RSB 562
April 16, 2021

NHTSA #21V 088
TC #2021-073

RECALL SERVICE BULLETIN

Recall Service Bulletin RSB21-260-001

Figure 1

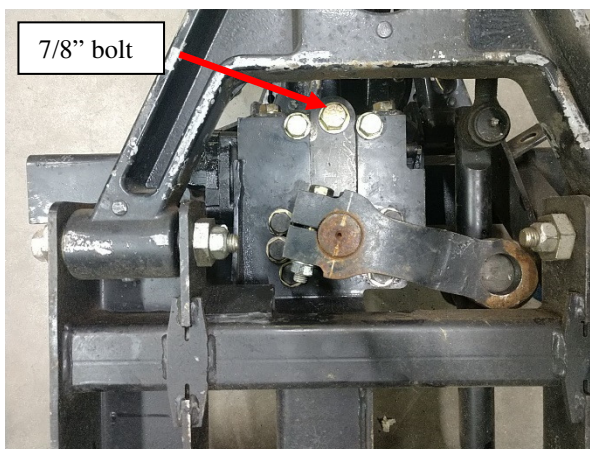
1. Raise the vehicle high enough to get the tires off the ground and safely support per industry standards.
2. Begin with the driver side steering gear and reference Figure 1. Remove the 7/8" bolt and flat washer attached to bottom of steering gear. Discard bolt and washer.
3. Clean the threaded hole in the steering gear.
4. Install new 7/8-14 x 2.00" bolt with 7/8" Nord-Lock® washer. Torque to 500 LB-FT +/- 25 LB-FT. Mark fastener to indicate it has been torqued.

5. Remove one of the two 3/4" bolts closest to the 7/8" bolt attached to bottom of steering gear mounting plate. Discard bolt and flat washer.
6. Clean the threaded hole.
7. Install new 3/4-16 x 1.50" bolt with 3/4" Nord-Lock® washer. Torque to 300 LB-FT +/- 10 LB-FT. Mark fastener to indicate it has been torqued.
8. Repeat steps 5 thru 7 for other 3/4" bolt nearest the 7/8" bolt.

Figure 2

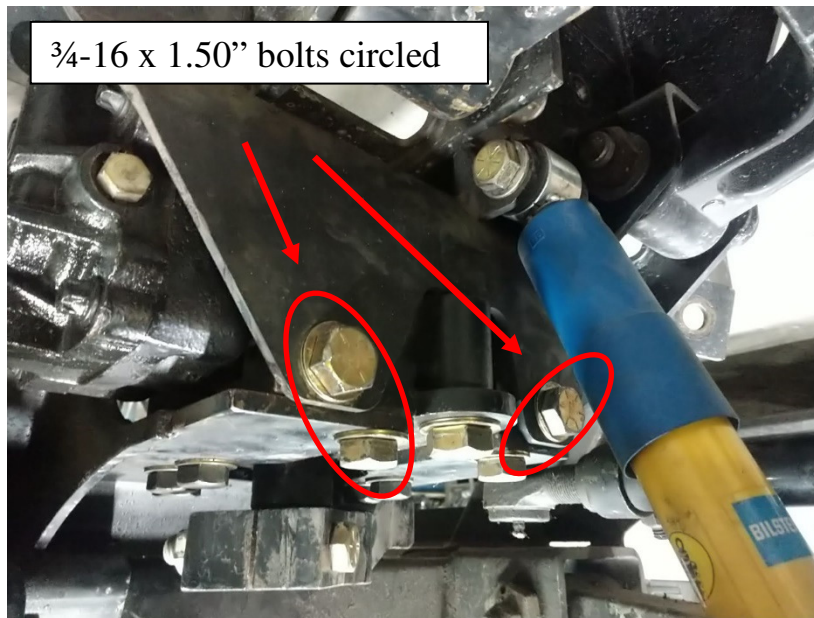
9. Referencing Figure 2, remove one of the two $\frac{3}{4}$ " bolts attached to side of steering gear mounting plate. Discard bolt and flat washer.
10. Clean the threaded hole.
11. Install new $\frac{3}{4}$ -16 x 1.50" bolt with $\frac{3}{4}$ " Nord-Lock® washer. Torque to 300 LB-FT +/- 10 LB-FT. Mark fastener to indicate it has been torqued.
12. Repeat steps 9 thru 11 for other $\frac{3}{4}$ " bolt attached to side of steering gear mounting plate.

Note: Shallow socket and open end wrench required to remove bolt behind shock absorber.

Figure 4

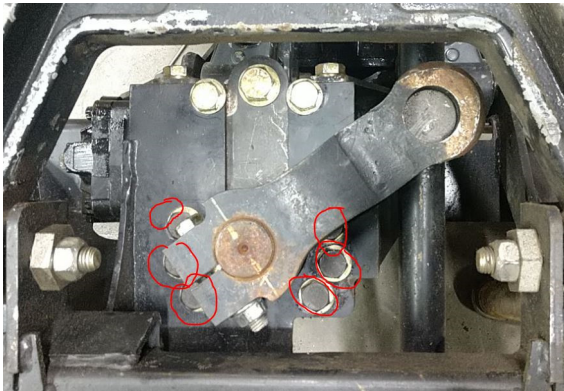
14. Referencing Figure 4, remove one of the six $\frac{3}{4}$ " bolts surrounding the output shaft. Discard bolt and flat washer.

15. Clean the threaded hole in the steering gear.
16. Install new $\frac{3}{4}$ -16 x 2.00" bolt with $\frac{3}{4}$ " Nord-Lock® washer. Torque to 300 LB-FT +/- 10 LB-FT. Mark fastener to indicate it has been torqued.
17. Repeat steps 13 thru 16 for each of the remaining five $\frac{3}{4}$ " bolts surrounding the output shaft.

Figure 6

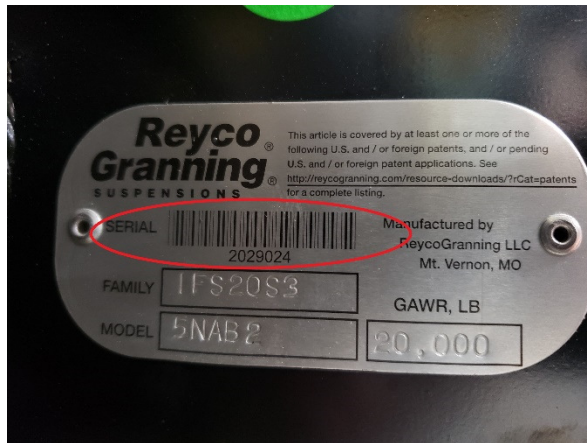
18. If suspension model is an IFS2000S3, repeat steps 3 thru 17 on the passenger side for the slave gear.
19. Document IFS serial number.
 - a. Serial number is listed on data tag located on front face of driver side air spring tower. Reference Figure 5 & Figure 6 for serial number location.
